# SITE PLAN & ARCHITECTURAL COMMISSION AGENDA SEPTEMBER 18, 2015

50. Public Hearings.
    - New Business.
      - 50.1. AC-15-013 Request for revision to approved plans for the construction of a 1,850 square foot Starbucks on a 1.01 acre parcel located at 2676 East Barnett Road, on the south side of Barnett Road between Black Oak Road and Murphy Road, within a C-C (Community Commercial) zoning district. Oregon Architecture, Inc. (Mark McKechnie) Applicant/Agent.

- 50.2 AC-15-087 Consideration of plans for the construction of a 44-unit multi-family residential project on a 0.812 acre parcel, located on the east side of Crater Lake Avenue, between Roberts Road and Brookhurst Street, within the MFR-20 (multiple-family residential – 20 dwelling units per gross acre) zoning district. Terry/Diane Buntin, Applicants; Ron Grimes Architects (Dave Evans), Agent.

Request for revision to approved plans for the construction of a 1,850 square foot Starbucks on a 1.01 acre parcel located at 2676 East Barnett Road, on the south side of Barnett Road between Black Oak Road and Murphy Road, within a C-C (Community Commercial) zoning district.

1 SITE PLAN  
SCALE: 1/8" = 1'-0"

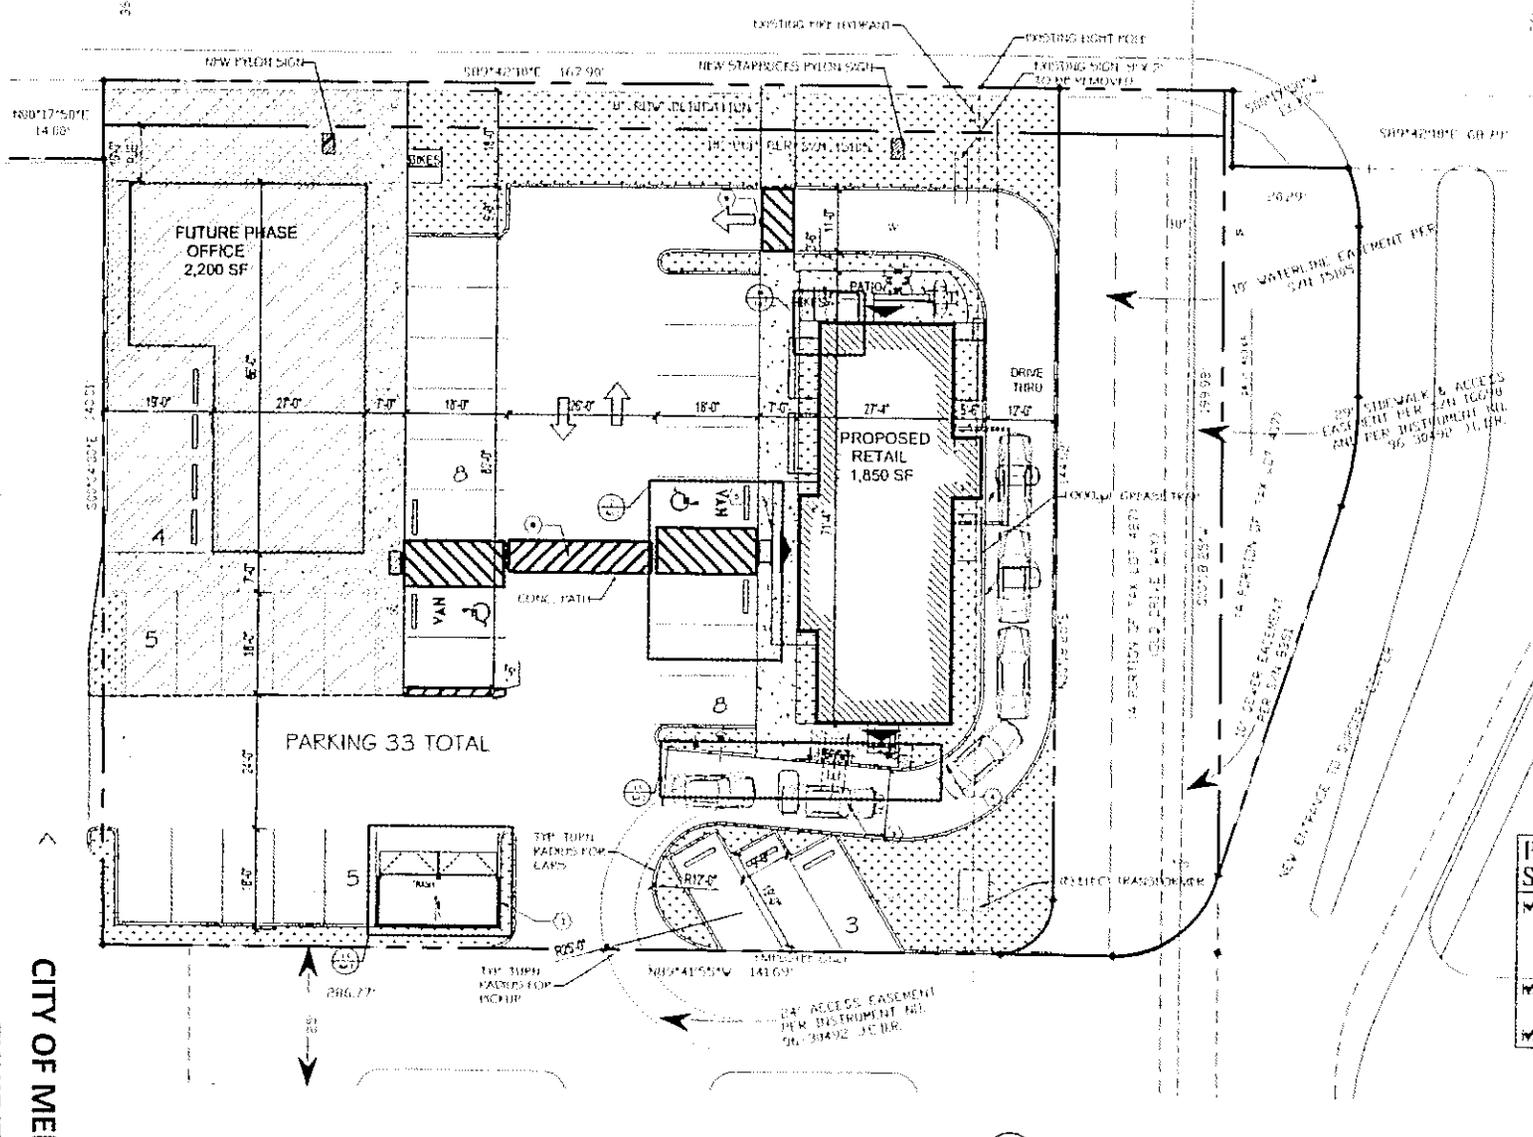
This commission voted to approve plans for this project at the hearing on June 05, 2015. As part of that approval, the Commission approved the applicant's request for less required parking for the Starbucks building. The Commission approved the proposed site plan with the removal of the three angled parking spaces along the southern boundary of the site (Exhibit A).

One version of the site plan submitted for consideration by the Commission (Exhibit D) consists of the plan approved on June 05, 2015 with the three angled spaces remaining on the southern boundary of the site. The three angled spaces were specifically identified by the Commission in the June 05, 2015 hearing as being problematic and were thus required to be removed.

1 SITE PLAN  
SCALE: 1" = 10'-0"

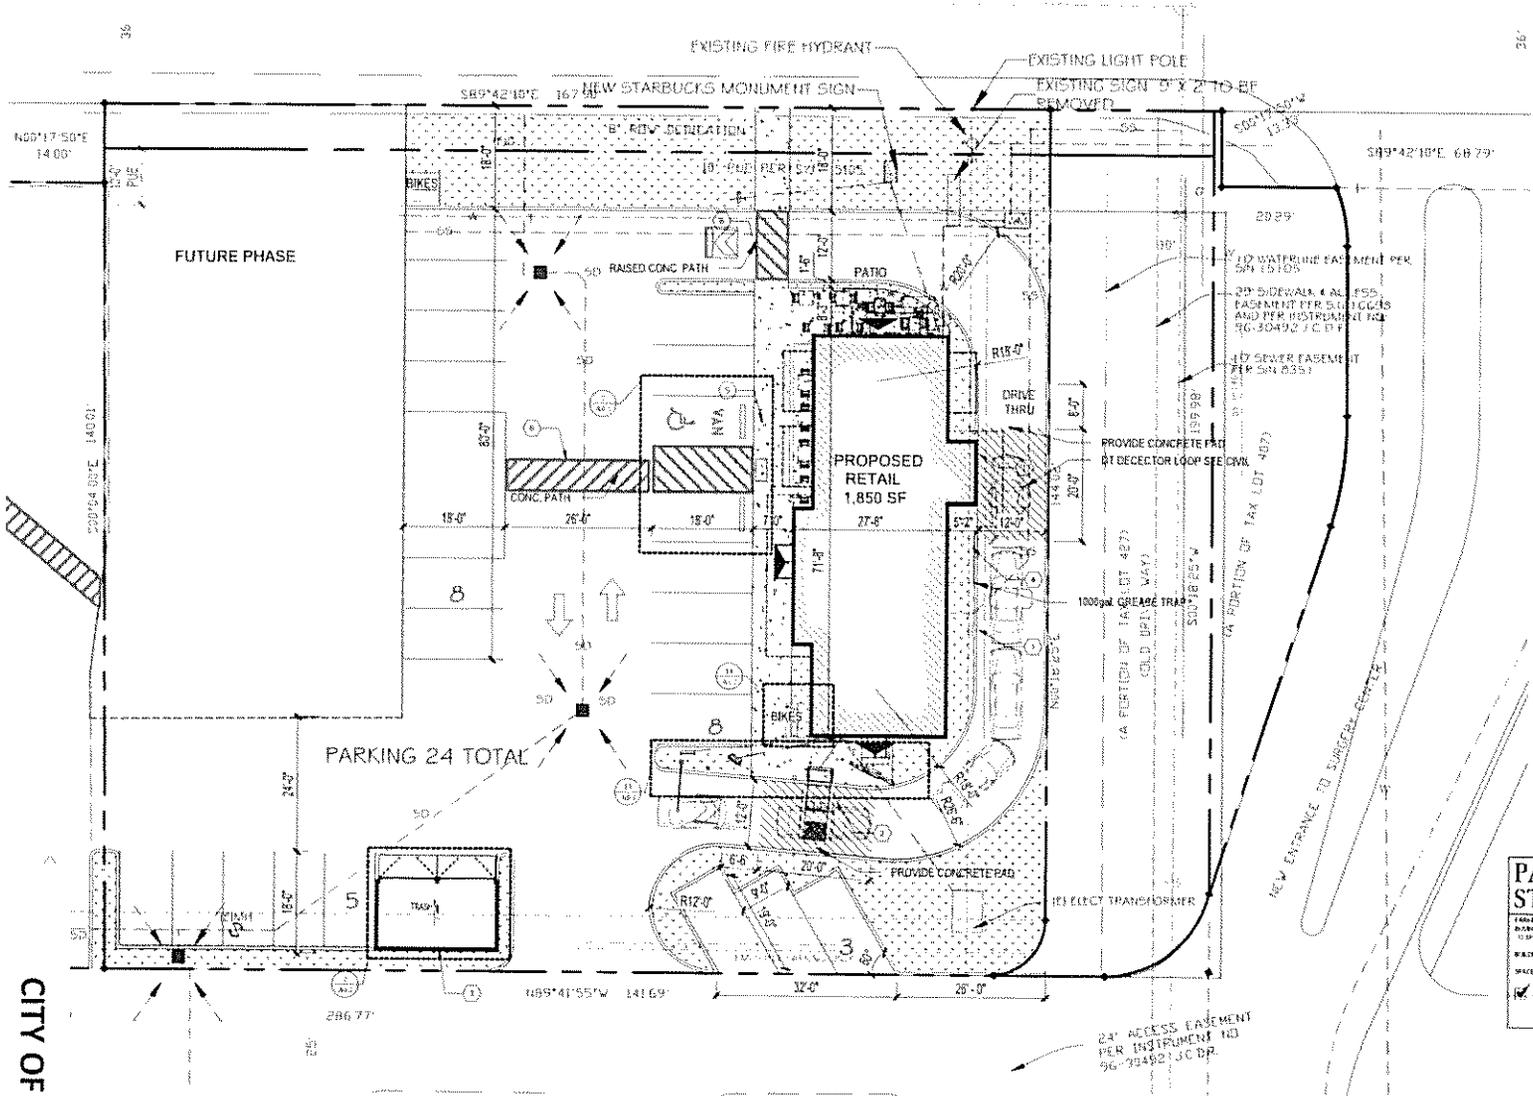
The second version of the site plan submitted for consideration (Exhibit E) is again another iteration previously considered by the Commission. This version has the trash enclosure on the southern boundary in place of the three angled spaces. In a previous hearing the Commission had concerns about orientation of the trash enclosure opening into the shared access drive aisle.

The proposal for this site has been reviewed and revised multiple times. The Commission has repeatedly expressed concern over the site layout, parking, and overall function of this site, particularly in relation to the shared access drive aisle to the south. Staff has suggested alternate site layout options to achieve the parking necessary and address the concerns of the Commission. The applicant has not been open to alternate site designs and has chosen to bring back site plans to which the Commission has been dissatisfied with in previous hearings. For these reasons, Staff does not support the requested revision and recommends that the Commission deny the proposed revision to AC-15-013.

1 MASTER SITE PLAN  
SCALE: 1/8" = 1'-0"

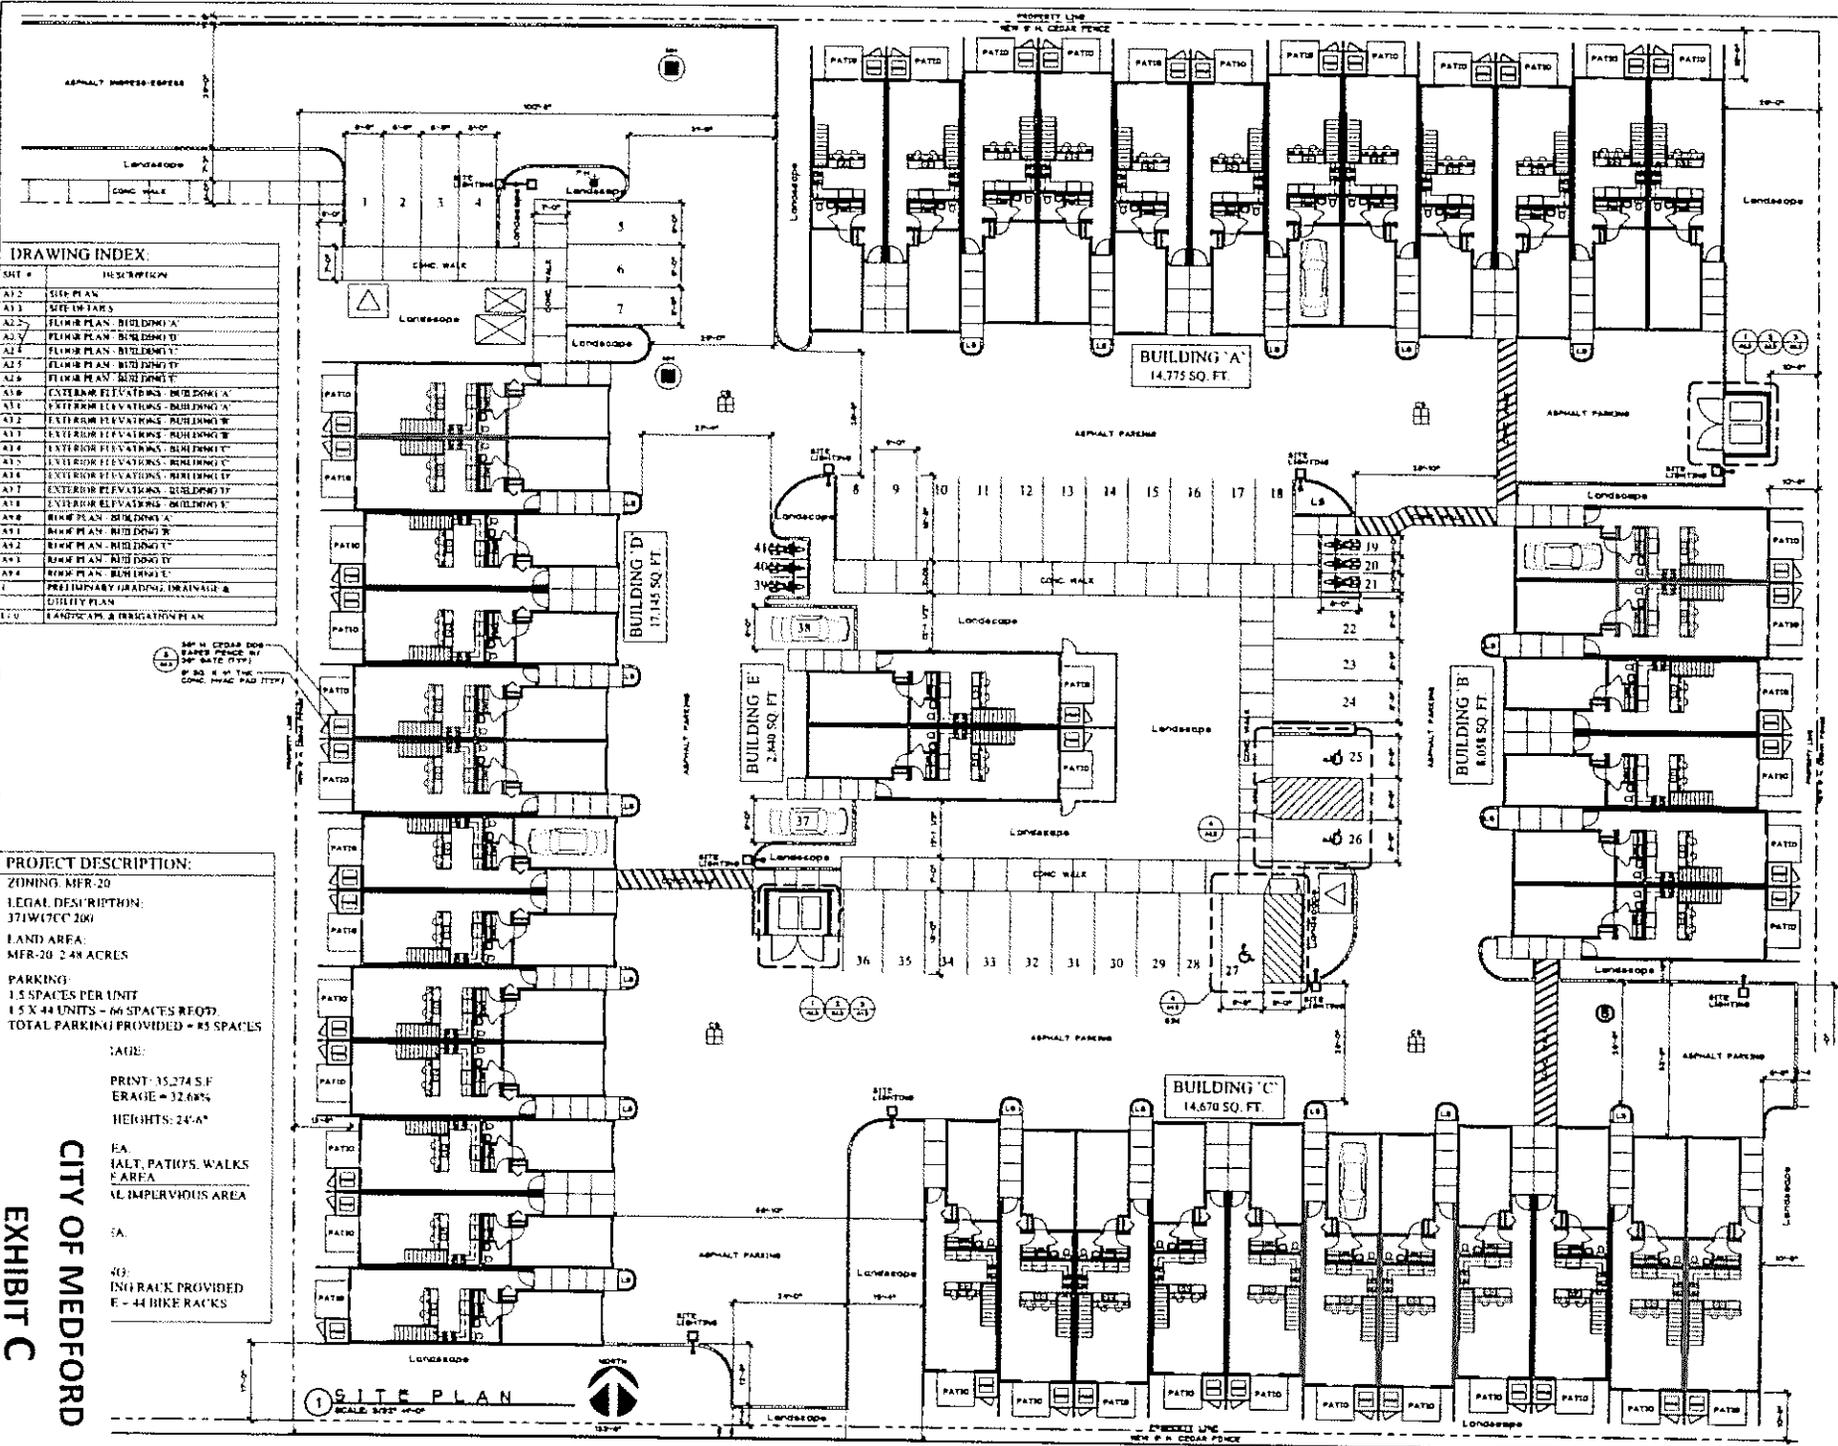
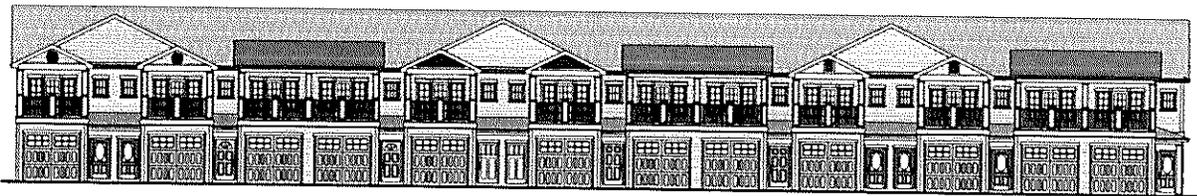
Staff suggests that the Commission consider the overall functionality, compatibility, and livability of this project. While the plan can be conditioned to meet all applicable code requirements, there are general site design issues which concern staff from a livability perspective. Based on the size of the proposed units (two and three bedrooms) it seems that families are the likely residents. However, there is very little open space provided, no pedestrian connections to North Medford High School (located only about 300 feet to the east), limited parking, no community amenities, and a single point of access. Staff has shared these concerns with the applicant. While density and infill are encouraged,

the solution proposed by staff is to reduce the total number of units to 38, which is still within the allowable density range. By eliminating six units, the site could accommodate additional parking and open space, provide a more community friendly common area in the center of the site, and enjoy additional design options (such as the location of trash enclosures, mail boxes, landscape features, etc.).

1. Remove the two-unit building from the site plan, leaving the center area for open space and parking.
2. Reduce the total number of units to 38, to be dispersed within four buildings located along the perimeter of the project.
3. Coordinate with adjacent property owners to provide a pedestrian connection to the east and/or south.

# PRELIMINARY GRADING, DRAINAGE & UTILITY PLAN

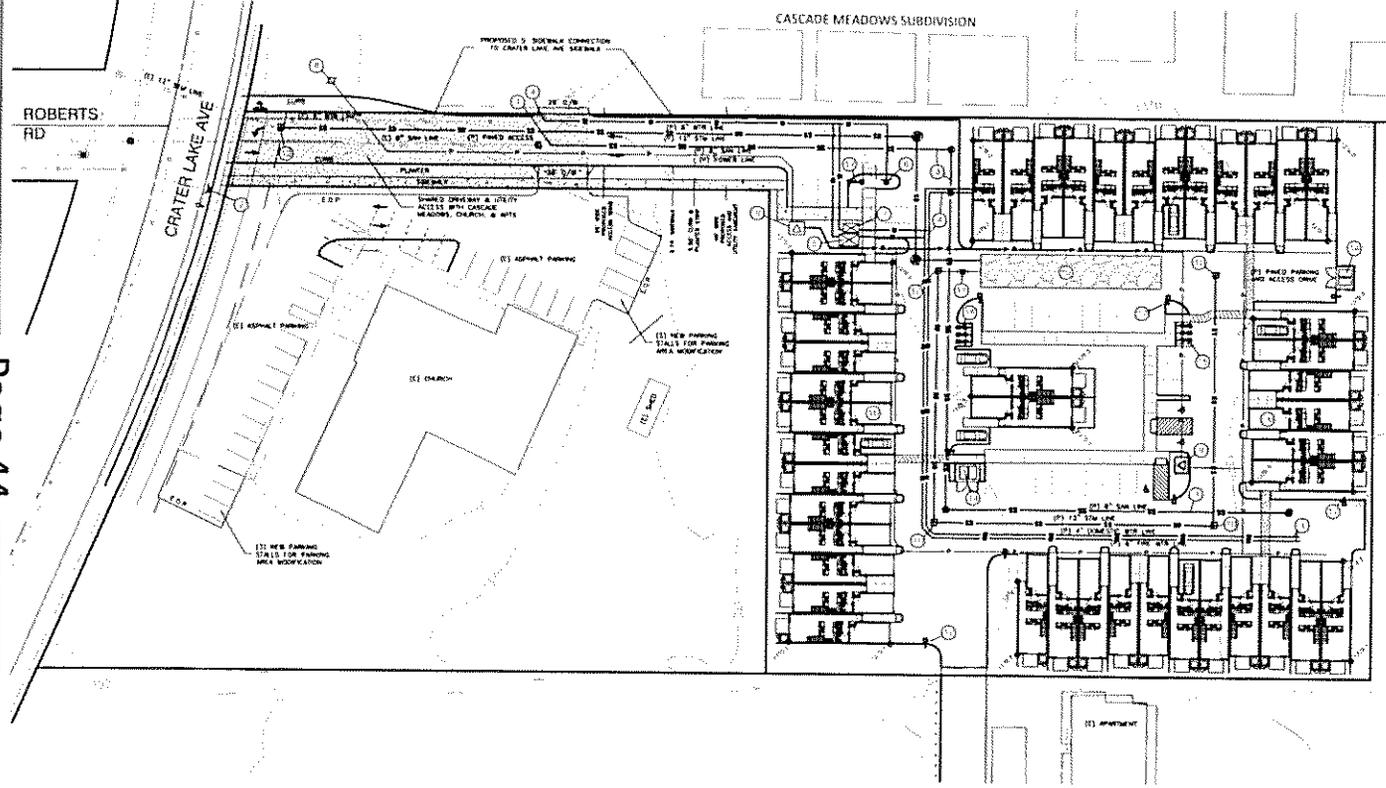
Hydrant locations shall be as follows: Two fire hydrants will be required for this project: One as shown on the plans (NW corner) and an additional fire hydrant in an island at the SE corner. This will meet the max. 300' spacing requirements for commercial developments.

Plans and specifications for fire hydrant system shall be submitted to Medford Fire Department for review and approval prior to construction. Submittal shall include a copy of this review (OFC 501.3).
